MINOR PERMIT MODIFICATION TO LLOYD AVENUE PHASE II, PADEP PERMIT NO. GP051501223-032

E & S PLAN

**INADVERTENT RETURN RECIRCULATION PLAN:
LLOYD AVENUE PHASE II**

CALN TOWNSHIP, CHESTER COUNTY

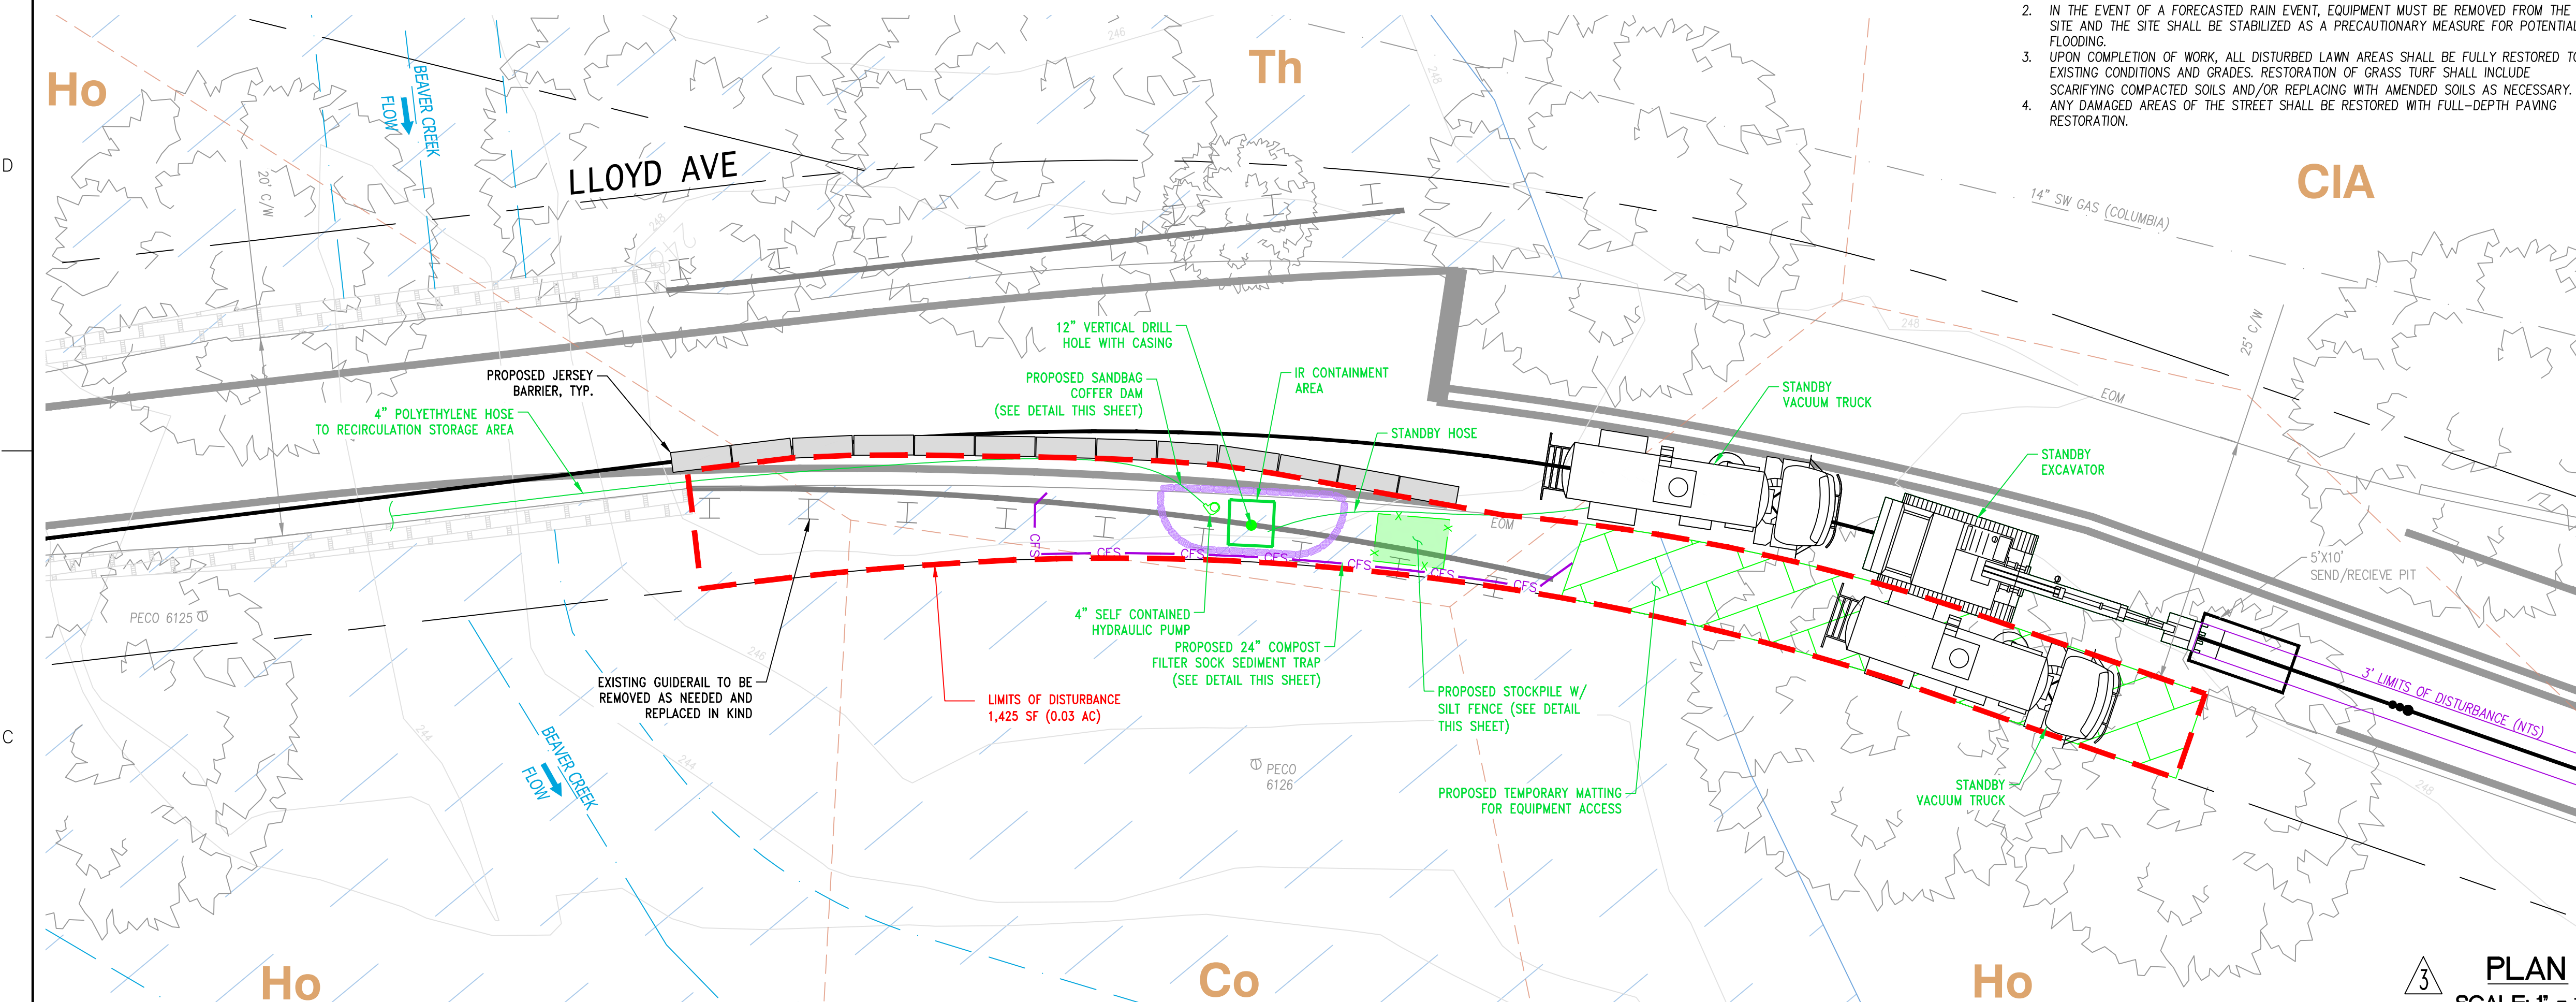
- ENHANCED CONTROLS:** BEFORE RESTARTING THE HDD
- INSTALL ADDITIONAL COMPOST FILTER SOCK AS IDENTIFIED ON THIS PLAN.
 - INSTALL ANY ADDITIONAL CONSTRUCTION MATTING.

- INSPECTIONS:** BEFORE RESTARTING THE HDD
- INSPECT ALL PREVIOUSLY INSTALLED EAS CONTROLS, ADDITIONAL CONSTRUCTION MATTING, AND THE IR CONTAINMENT STRUCTURE FOR INTEGRITY AND CONDUCT ANY MAINTENANCE AS NEEDED.

- USE ABACT BMPS
 - NO TREES OR SHRUBS SHALL BE CLEARED WITHIN THE LIMITS OF DISTURBANCE.
- SITE PREPARATION:** BEFORE RESTARTING THE HDD
- ALL EQUIPMENT AND MATERIALS, INCLUDING SUPPLEMENTAL EQUIPMENT AND MATERIALS RELATED TO THIS IR RECIRCULATION PLAN AND IN ACCORDANCE WITH THE HDD INADVERTENT RETURN PREPAREDNESS, PREVENTION AND CONTINGENCY PLAN, WILL BE STAGED WITHIN THE LOD AND WILL BE READY FOR IMMEDIATE USE. THIS LIST INCLUDES AT A MINIMUM:

- Excavator on-site
 - Skid Steer staged on HDD Pad
 - Additional Timber and Composite Mats should they be needed.
- OPERATIONS:**
- A 4-INCH SELF-CONTAINED HYDRAULIC PUMP WILL BE USED TO DEWATER THE AREA WITHIN THE IR CONTAINMENT STRUCTURE INTO ONSITE STORAGE TANKS. THE 4-INCH PUMP WILL BE USED TO EMPTY THE IR CONTAINMENT STRUCTURE OF WATER PRIOR TO INITIATION OF HDD OPERATIONS. THE DEWATERED STATUS WILL BE MAINTAINED THROUGHOUT THE OPERATION.

- ANY WATER OR DRILLING FLUID, OR COMBINATION THEREOF, EMERGING AS A RESULT OF THE HDD OPERATION WILL BE PUMPED TO THE RECIRCULATION STORAGE AREA USING VACUUM TRUCKS AND/OR PUMPS. ONE (1) VACUUM TRUCK WILL BE STAGED ON CONSTRUCTION MATS IN THE UPLAND AREA ADJACENT TO THE CONTAINMENT TO MITIGATE A RELEASE RATE THAT MAY OVERWHELM THE CONTAINMENT. IN ADDITION, A STANDBY VACUUM TRUCK AND THREE STANDBY PUMPS WILL BE ONSITE WITHIN THE HDD STAGING AREA.

- IF AN IR WERE TO OCCUR OUTSIDE OF THE IR CONTAINMENT STRUCTURE, THE FOLLOWING STEMS WILL BE TAKEN IMMEDIATELY:
 - NOTIFICATIONS WILL BE MADE IN ACCORDANCE WITH THE TRENCHLESS TECHNOLOGY INADVERTENT RETURN PREPAREDNESS, PREVENTION AND CONTINGENCY PLAN FOR LLOYD AVENUE PHASE II, PREPARED BY TOTAL ENGINEERING & CONSULTING SERVICES LLC., DATED APRIL 2024.

- AN IR WILL BE IMMEDIATELY CONTAINED USING SILT FENCE, COMPOST FILTER SOCKS, AND/OR SANDBAGS
 - AN IR WILL BE IMMEDIATELY RECOVERED USING HAND TOOLS, VACUUM TRUCKS, AND PUMPS
